APPEAL SUMMARY

Appeal ID: 20384	Project Address: 5510 N Denver Ave
Hearing Date: 5/15/19	Appellant Name: david sheerin
Case No.: B-001	Appellant Phone: (503)234-2945
Appeal Type: Building	Plans Examiner/Inspector: Robert Keal
Project Type: commercial	Stories: 4 Occupancy: R-2 Construction Type: V
Building/Business Name: Killingsworth N D Block	Fire Sprinklers: Yes -
Appeal Involves: Erection of a new structure	LUR or Permit Application No.: 18-272167-CO
Plan Submitted Option: pdf [File 1] [File 2]	Proposed use: R-2 Residential

Killingsworth N D Block

Ceiling/ Roof Assembly (1 Hr)

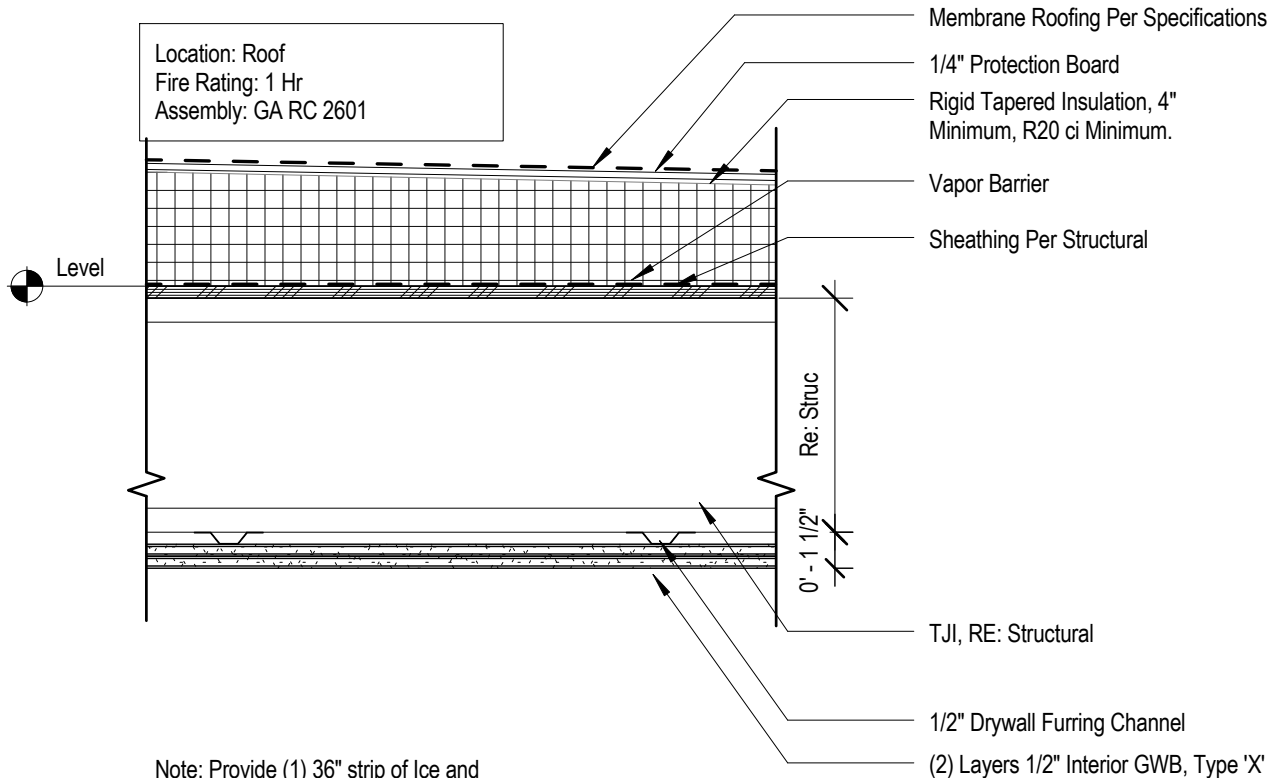
Appeal item 2

Code Section 1203.2

Requires	Enclosed attics and enclosed rafter spaces formed where ceilings are applied directly to the underside of roof framing members shall have cross ventilation for each separate space by ventilation openings protected against the entrance of rain and snow. Blocking and bridging shall be arranged so as not to interfere with the movement of air. An airspace of not less than 1 inch (25 mm) shall be provided between the insulation and the roof sheathing. The net free ventilating area shall not be less than 1/150th of the area of the space ventilated.
Proposed Design	We are proposing an unventilated Roof assembly with R-20 minimum thermal insulation and vapor barrier entirely above the roof deck. By placing the insulation above the roof deck, the Dew Point

occurs above the roof deck and not within the roof cavity. Because the condensation can only occur above the roof assembly, no ventilation is required within the roof assembly to draw unwanted water vapor out of the building.

Reason for alternative The proposed modification conforms to structural, energy conservation and life safety requirements.

This assembly has been accepted in the past by the City of Portland for non-ventilated low-slope roofs.

2. Unvented attic space: Granted as proposed.

Floor Plan -
Level 01

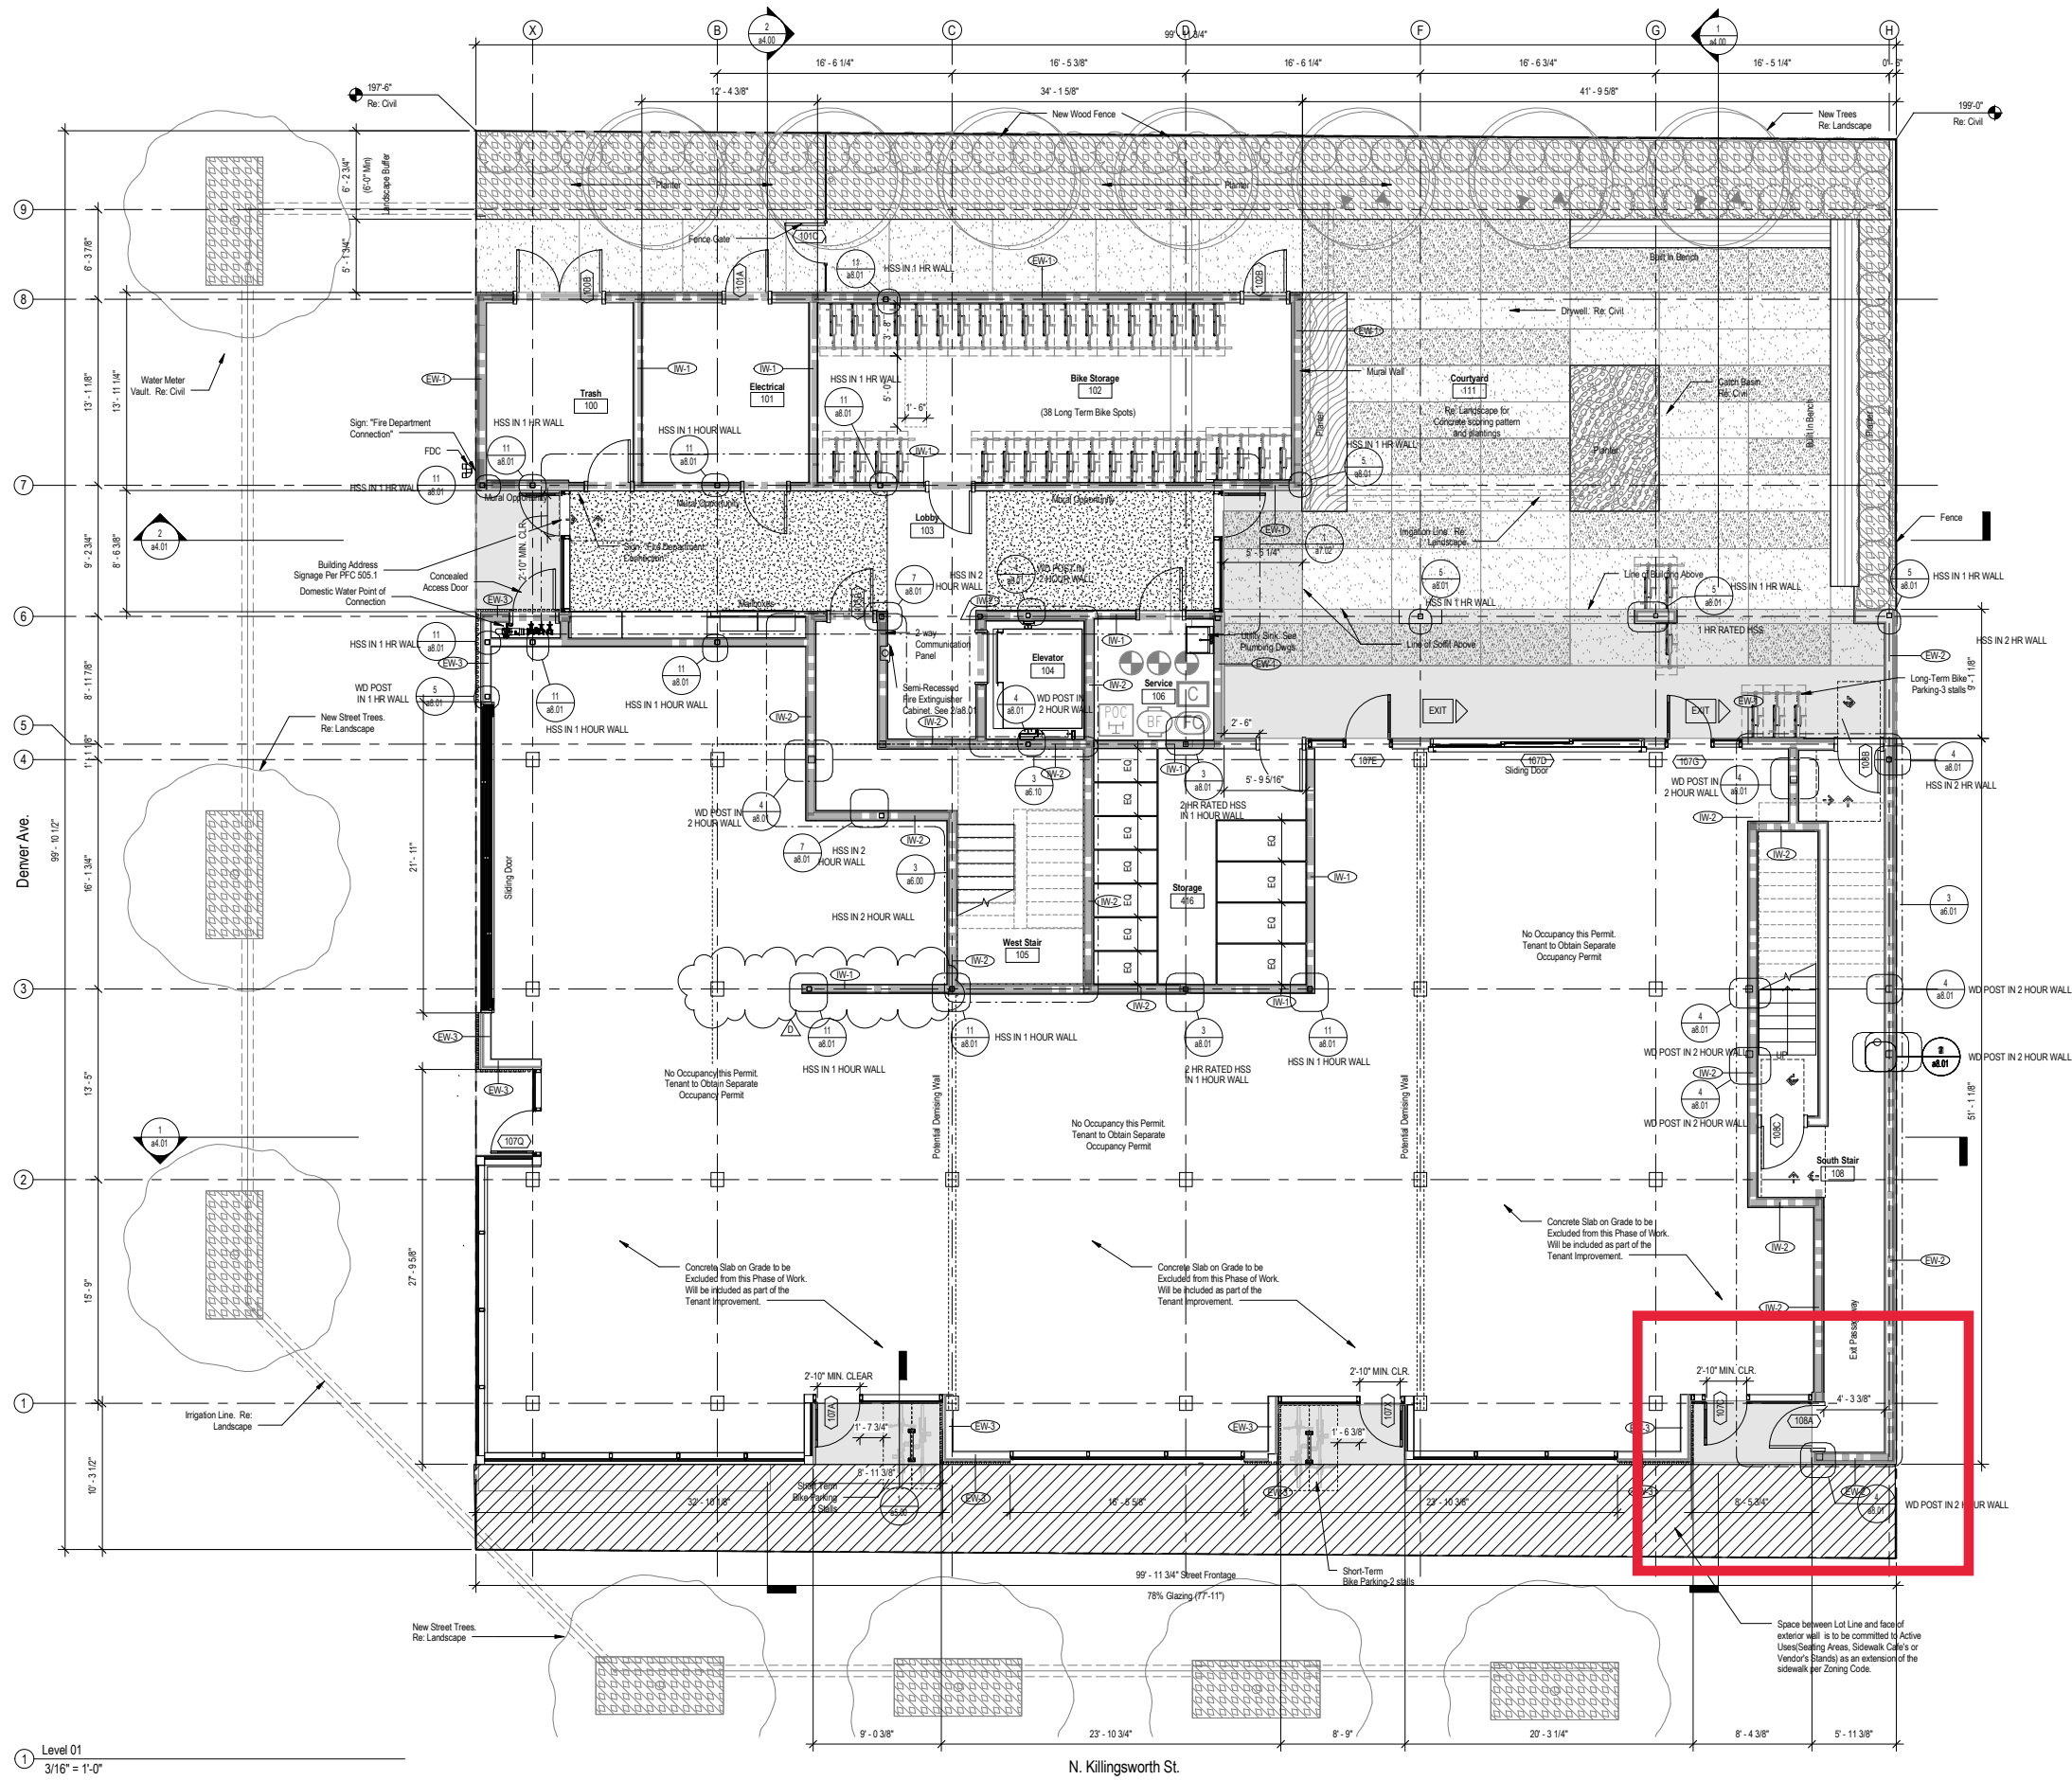
Appeal item 1

Code Section 1023.4 & 202

Requires	Exit Passageways on the Level of Exit Discharge shall terminate at an Exit Discharge. Exit Passgeways on other levels shall terminate at an Exit. Exit Discharge: That portion of a Means of Egress System between the termination of an exit and a public way.
Proposed Design	We will use a Tyco WS sprinkler system on the glazing at the exit discharge as a substitute for 2 hour fire rating, as indicated by Plans Examiner.
Reason for alternative	As indicated by the Plans Examiner, alternate will provide equivalent health, accessibility, structural capacity, energy conservation, life safety and fire protection to what the code requires.

1. Termination of exit passageway within building: Granted as proposed.
